**Sausalito – Marin City Sanitary District (NPDES No. CA 0038067)
Wastewater Treatment Plant Inspection
US EPA and San Francisco Regional Water Quality Control Board
Date of Inspection: Wednesday, March 21, 2007**

Report prepared by: JoAnn Cola Date prepared: 5/31/07

Figure 5: FFR #1. Note heavy flow from broken end cap on distributor arm and debris-clogged nozzles.

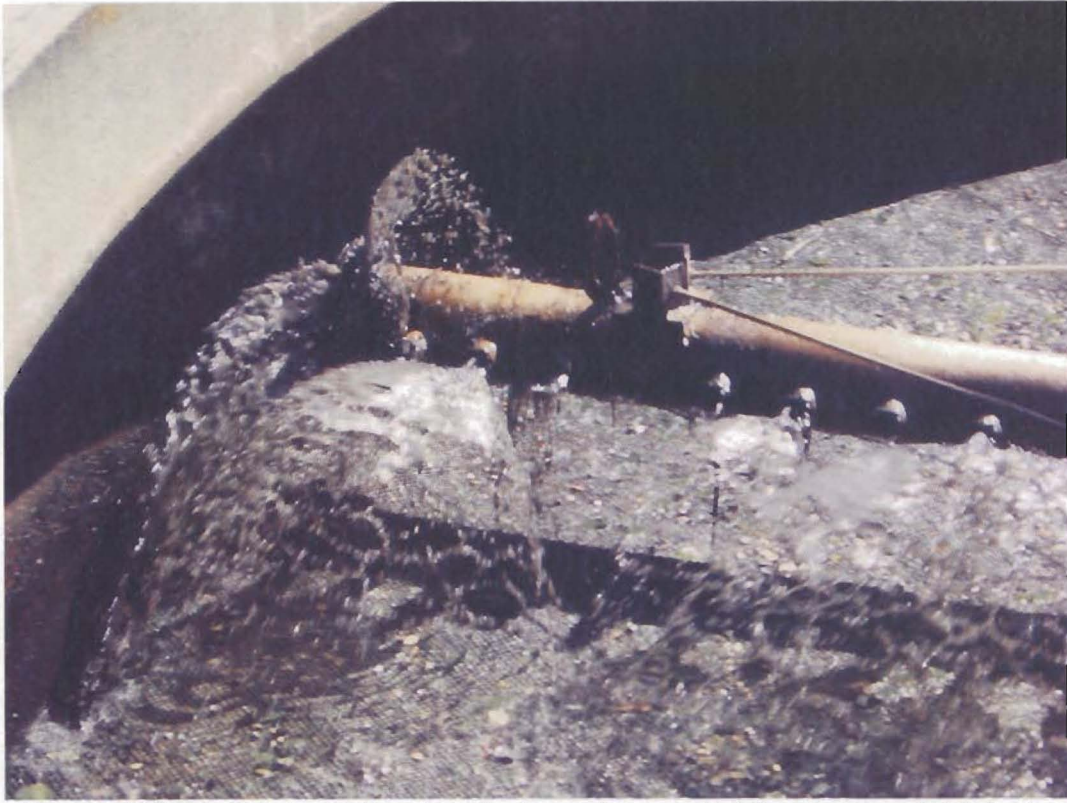
Debris clogged a number of distributor nozzles, and the end cap on a distributor arm of FFR #1 appeared to be broken (Fig. 5). The distributor arm on FFR #1 appeared to rotate slower than the distributor on FFR #2. FFR #2 appeared to have more evenly distributed flow. Uneven distribution of flow across the FFRs would likely cause a number of operational problems, including "short-circuiting" of flow through the reactors, uneven flushing of the biomass, and reduced secondary treatment efficiency. According to the CH2M Hill report, distributor arm speed is controlled only by flow to the arm – the more flow, the faster the distributor arm is propelled.

Figure 10: Location of outfall pipe. Note patches of small bubbles floating at bay surface next to plant, which were visible along the shore adjacent to the plant. Cause of bubbles is unknown.

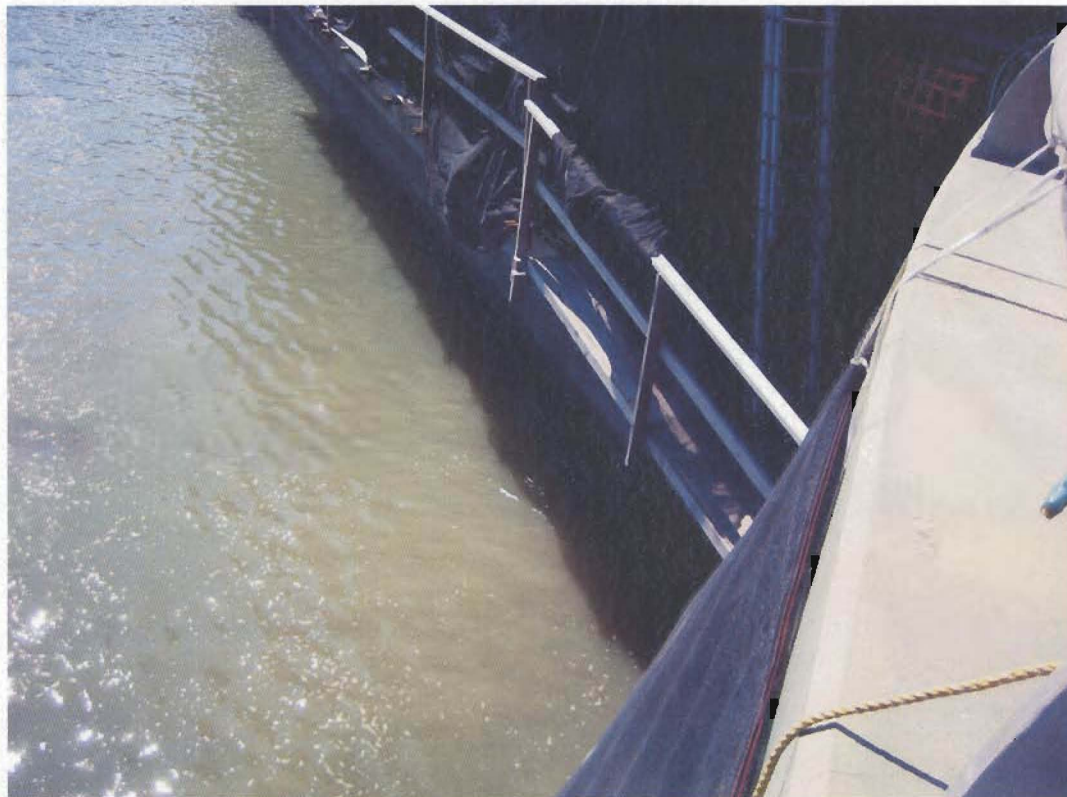
The outfall is located beneath the FFRs (Fig. 10), and is not visible unless tide is low. Discharge occurs 300 feet from the facility into San Francisco Bay.
